Center Street Commercial Building Responses to Comments

MIG - PEMS – Pam Steele, Principal
December 2017

Introduction

Grading and Drainage Plans

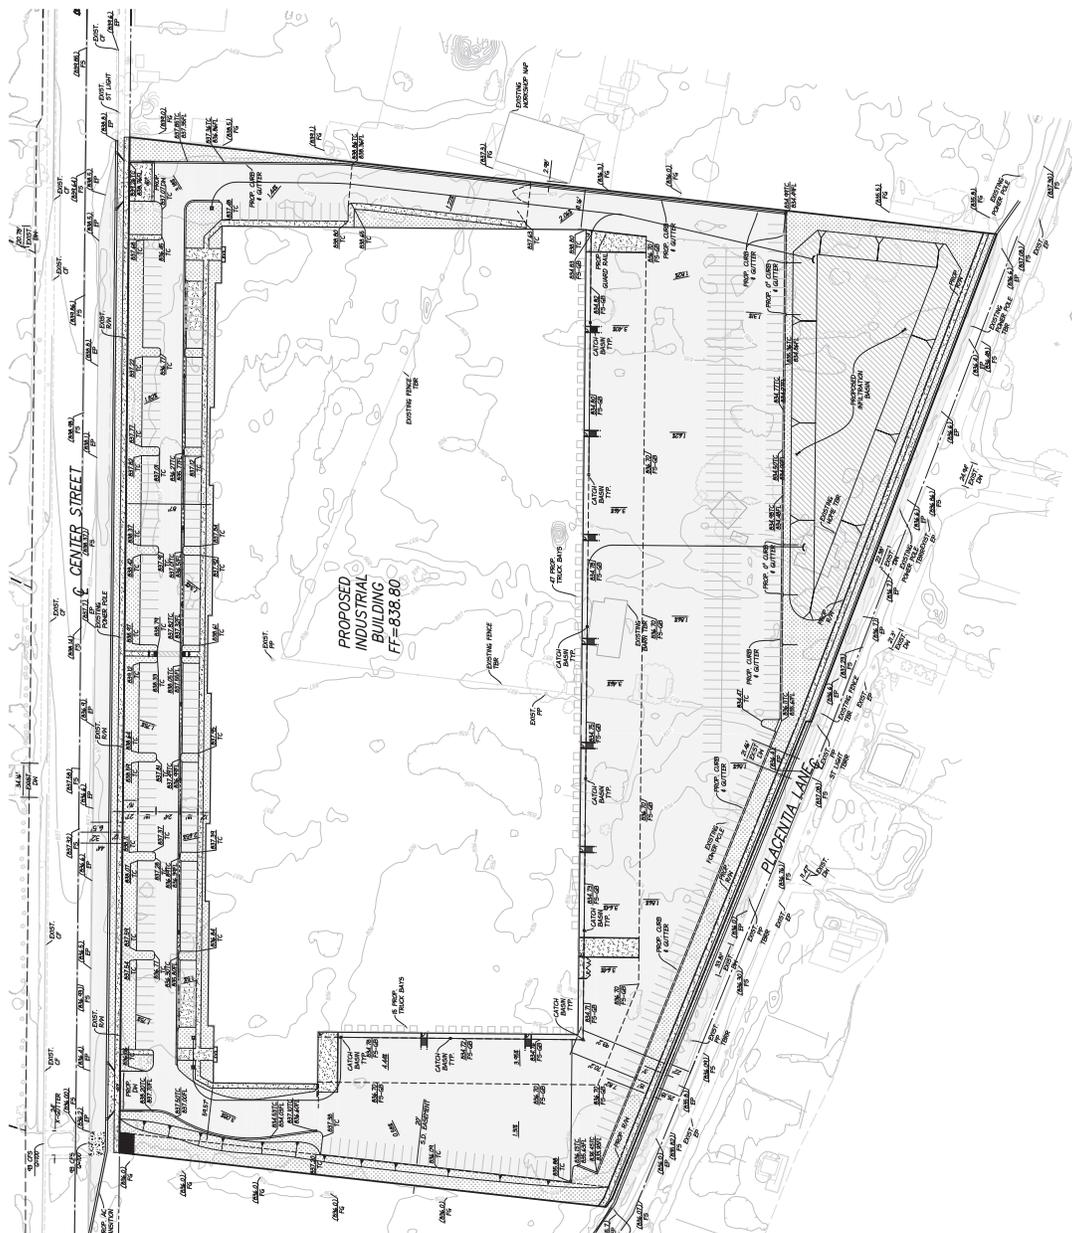
- In Appendix F, Page 23, Appendix 2, the Grading and Drainage Plans are unreadable. H36
- In Appendix F, Page 24, Appendix 3, Soils Information – Geotechnical Study and Other Infiltration Testing Data, the page is blank. Critical infiltration data (and presumably other soils data) are missing. H37

This comment has been received and noted. The Table of Contents has been updated to reflect the correct pagination. Subsections have been re-numbered and page numbers have been provided for each of the Appendices for ease of reference. Appendix F sub-Appendices 3, 8 and 9 of the project Hydrology Report were, in fact, missing as stated by the commenter. This is due to the fact that the Preliminary Hydrology Report, and not the Final Hydrology Report, was included in the IS/MND appendices. The Final Hydrology Report is included in this Response to Comments (see Attachment B) which includes sub-Appendices 3 (Soils Information), 8 (Source Control), and 9 (Operation and Maintenance).
